Access Compliance Report

Public Rights-of-Way

(Curb Ramps)

Intersection ID: 22860	Main Street: COUNTRYMENS_CT	Cross Street: SHARON_LAKES_RD	Location: E
ADA ID: 75E943ECE42	Ramp Type: BlendTrans1	Initial Pass/Fail: Pass	Overall Compliance: No
Severity Score: 2.5			
Codes/Mitigation Info/Possible Solution		Field Measurements/Component Compliance

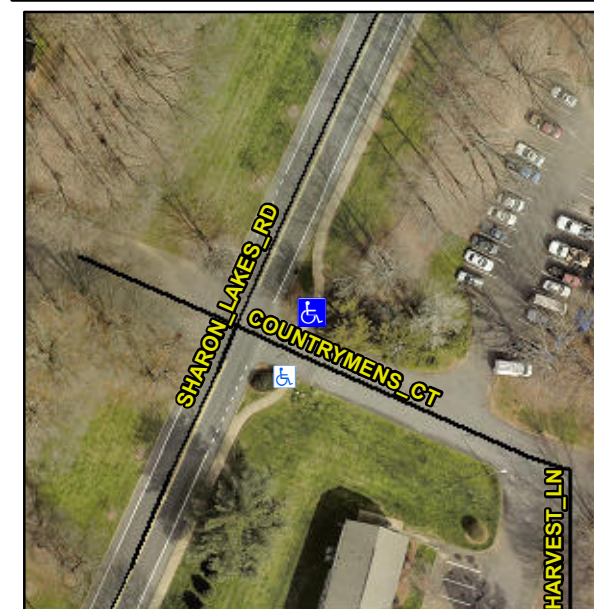
Remove & Replace Curb Ramp With Two New Directional Ramps or Equivalent.

ASP LIP 1.5

R304.2.2-Perp, R304.3.2-Para, R304.5.3, R305.1.4
